FINAL
Environmental Impact Report

**1145 Market Street
Office Building**

October 20, 1983

Fig. R-7

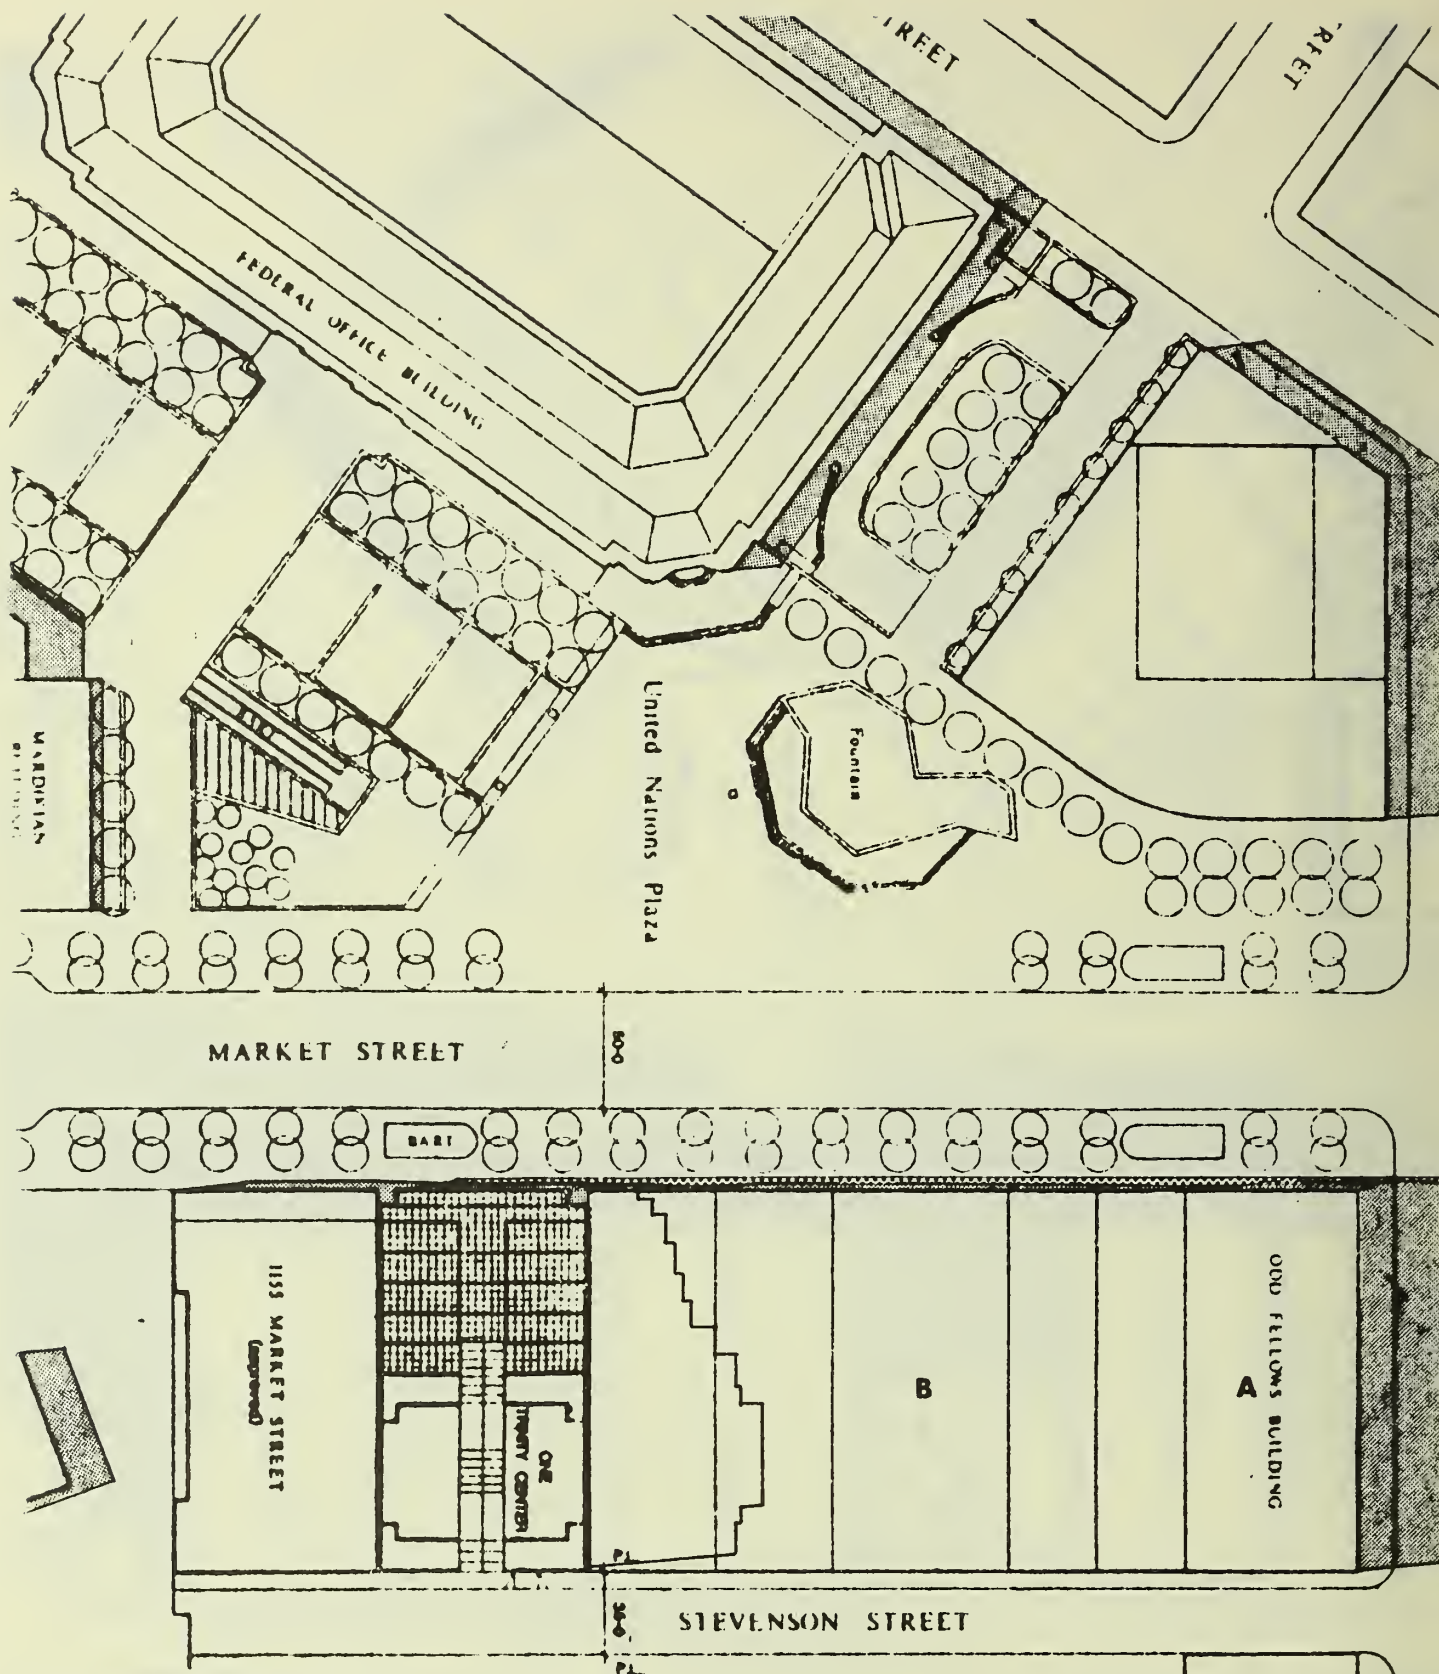
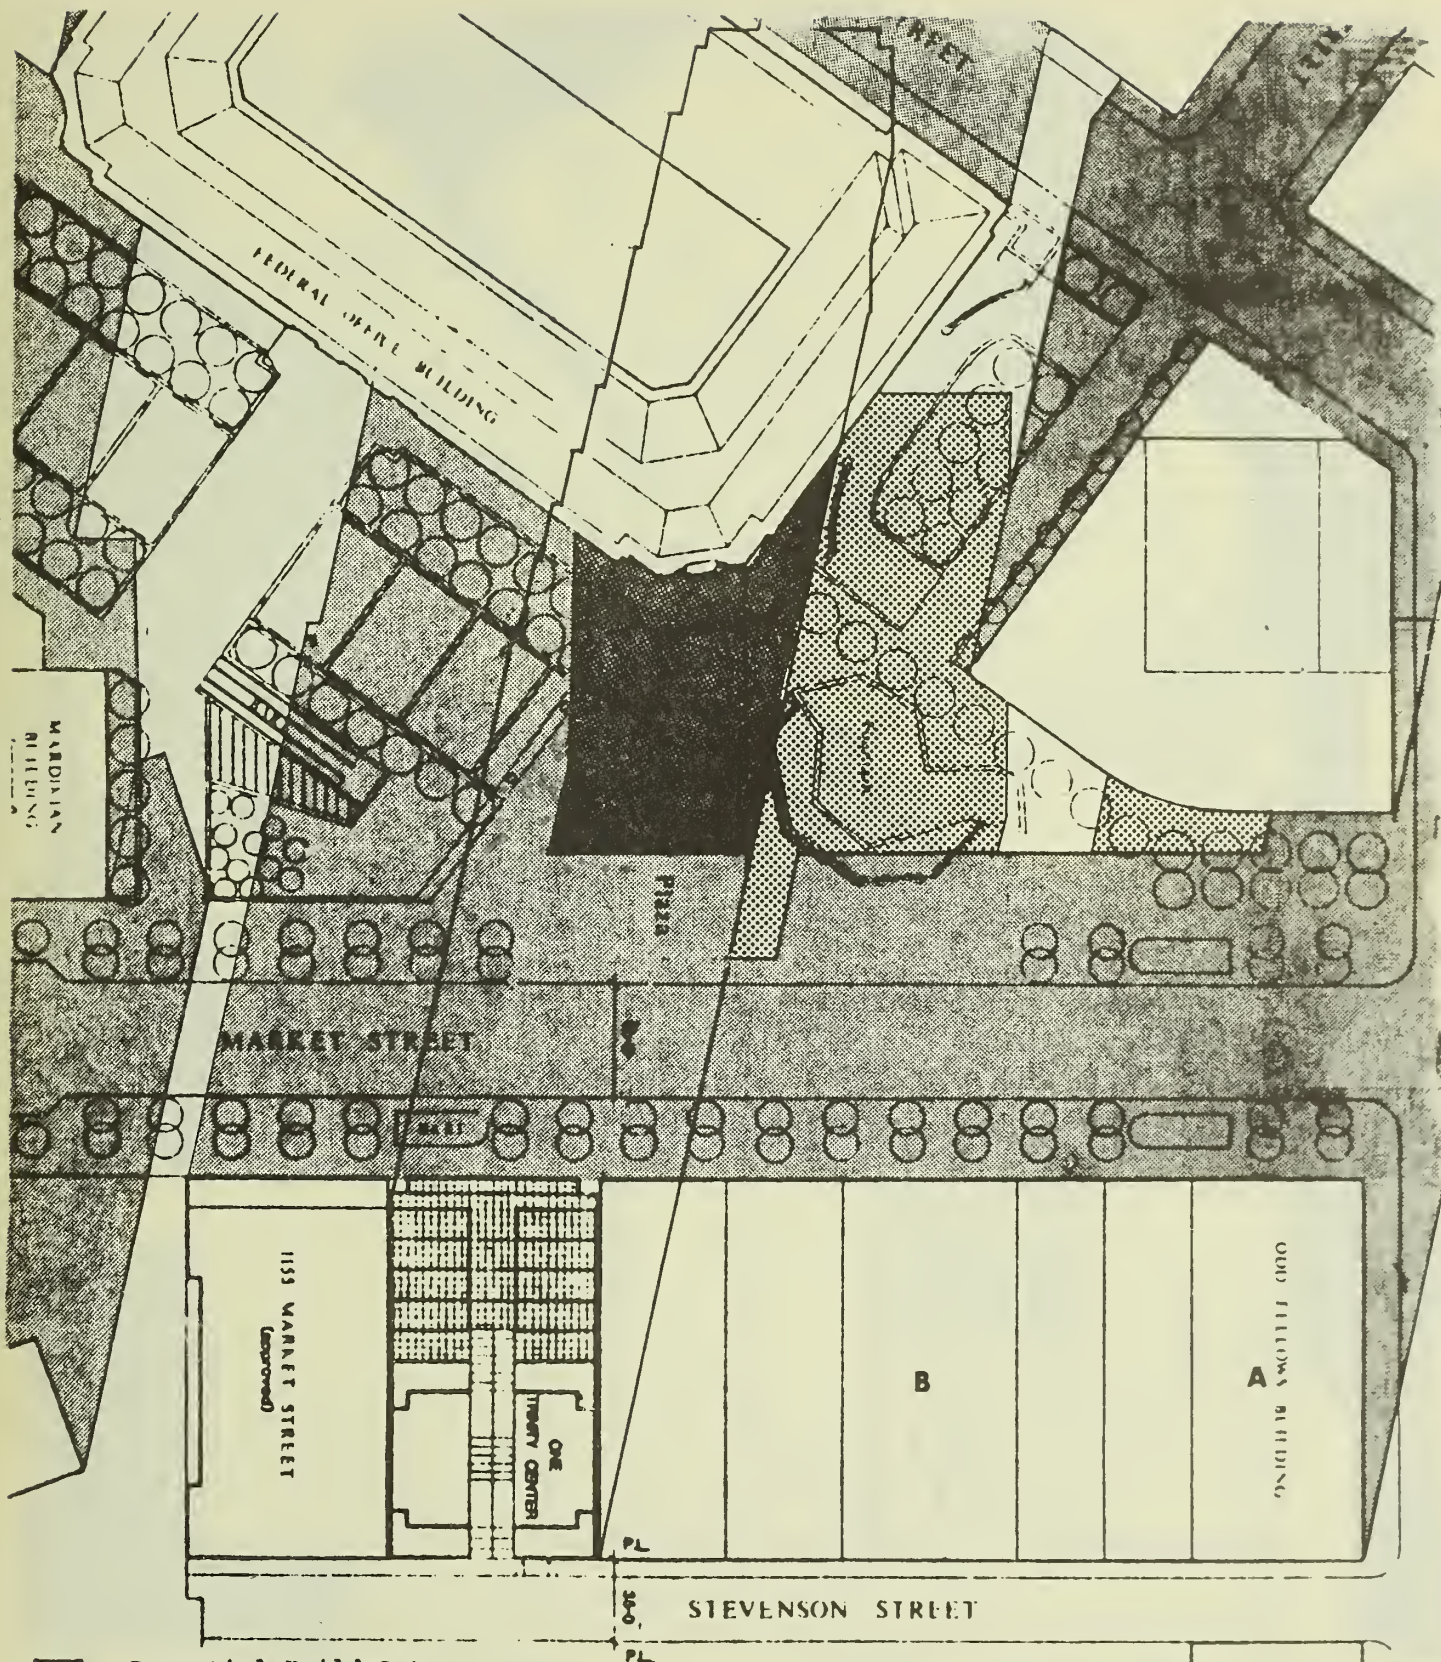
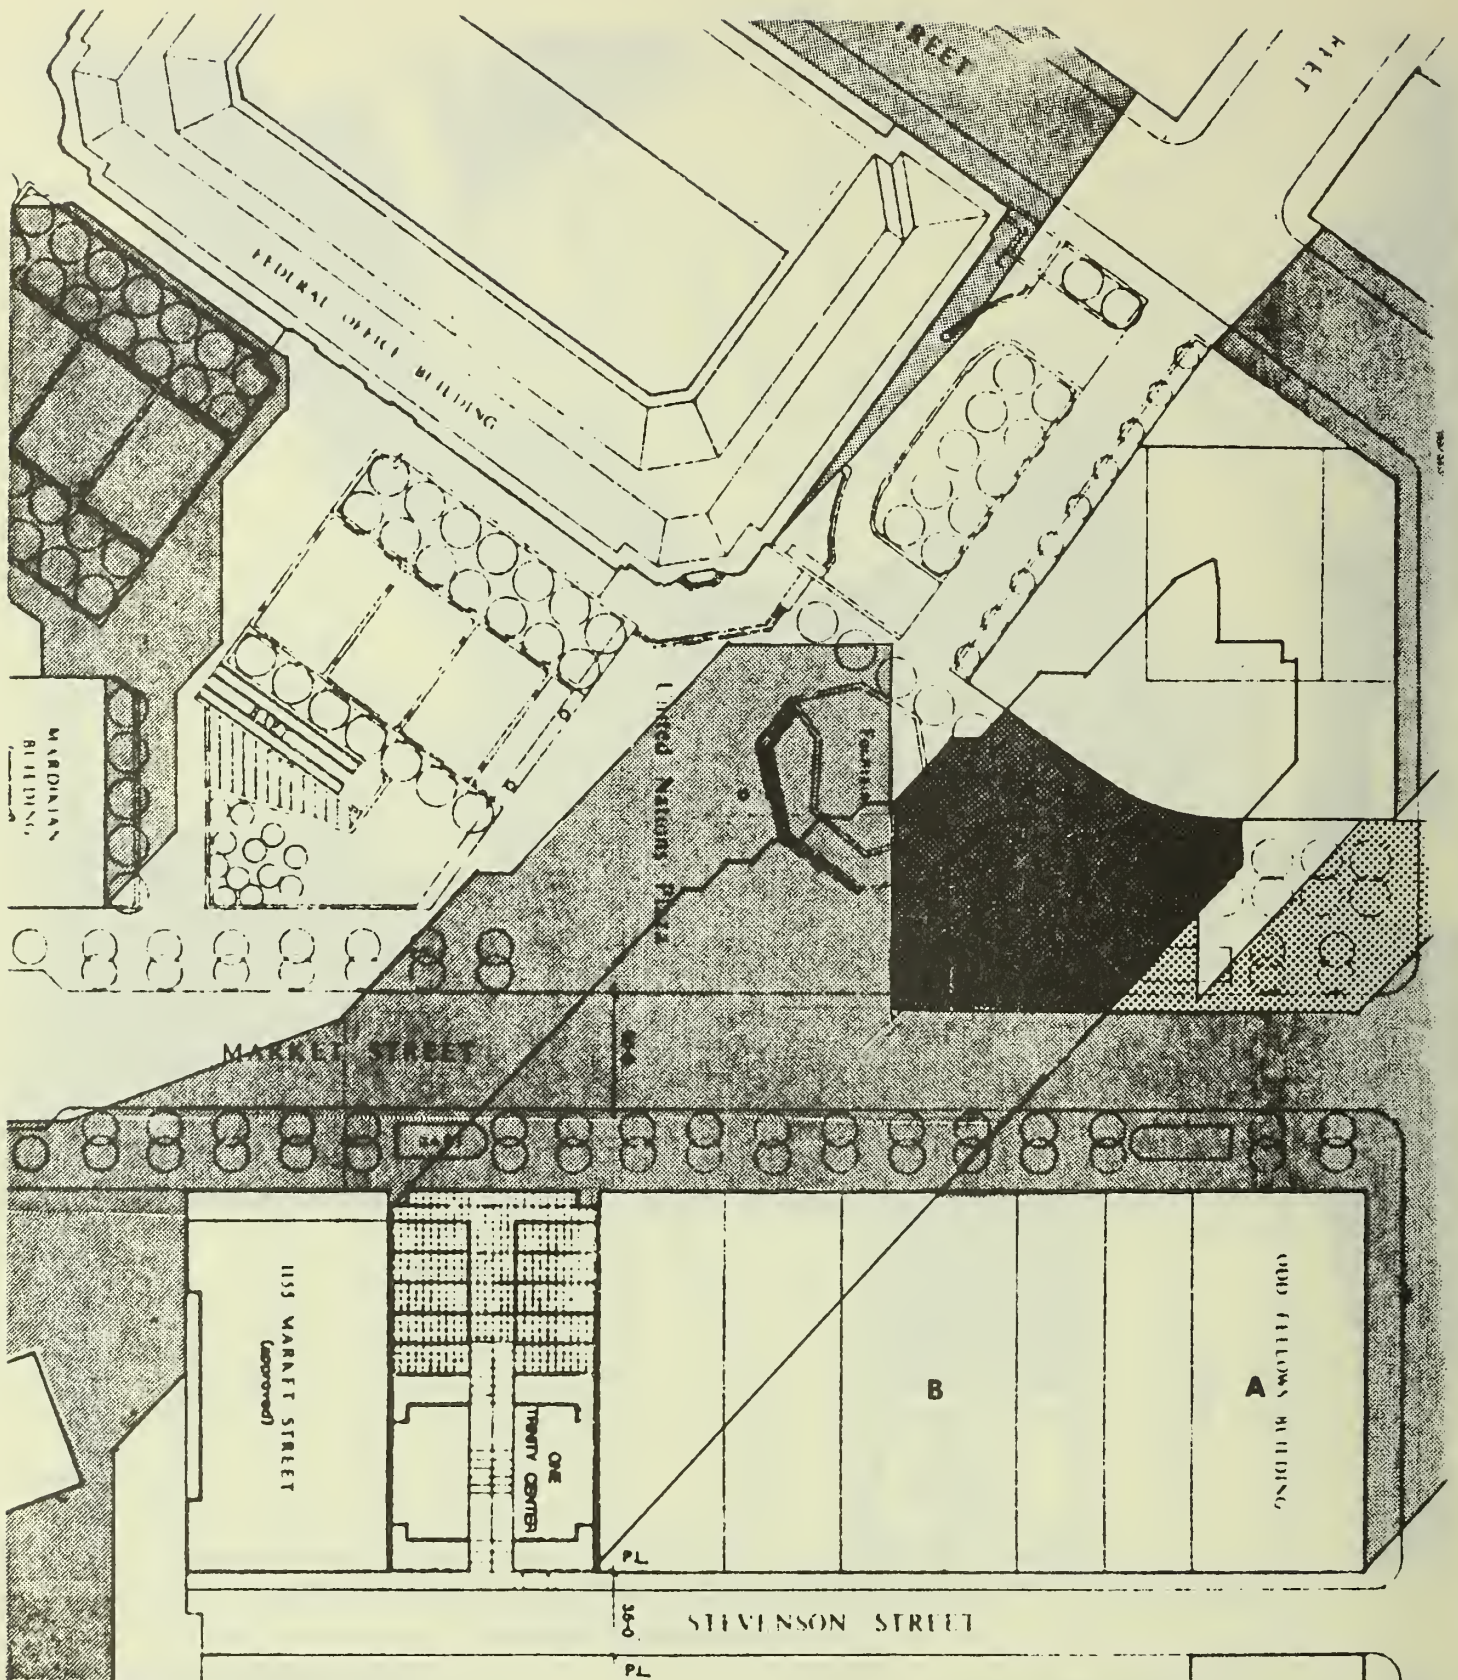
RESPONSE

The shadow analysis for the project was prepared as part of the Initial Study and Preliminary Negative Declaration issued by the Department of City Planning on May 21, 1982. The Initial Study is included as Appendix A of the EIR. On September 2, 1982, the Commission determined that an EIR was required on the proposed project providing further impact analysis for growth inducement cumulative transportation and cumulative air quality impacts; shadows were not identified as a potentially significant impact.

The shadow analysis indicates that the project would cast a shadow (assuming sunshine every day of the year) beyond the north curb of Market Street after 10:00 a.m. for about 200 days a year for about one and one-half to two hours on each morning during the months of January through March, September through December. The project would, in conjunction with other projects in the area, shadow a portion of the United Nations Plaza Fountain about 60 days a year for about one and one-half to two hours each day during the months of November through January. Although not precisely indicative of cloudiness conditions in San Francisco, it is noted that cloudiness measurements taken at the San Francisco International Airport show that

Shadow studies for the project have been prepared by Peter Bosselmann of the UC Berkeley Environmental Simulation Laboratory (ESL), which appear as Figures R-2 through R-10 on pages 25-33 of this document. The study reflects sun shading concepts and criteria introduced in the ESL report, Sun and Light for Downtown San Francisco, April 1983, which have been incorporated into the Department of City Planning's proposal for the Downtown Plan, August 1983. As compared to the shadow studies originally prepared for the project that appear on pages A-49 through A-56 of the EIR, the Bosselmann study uses the most current methodology.
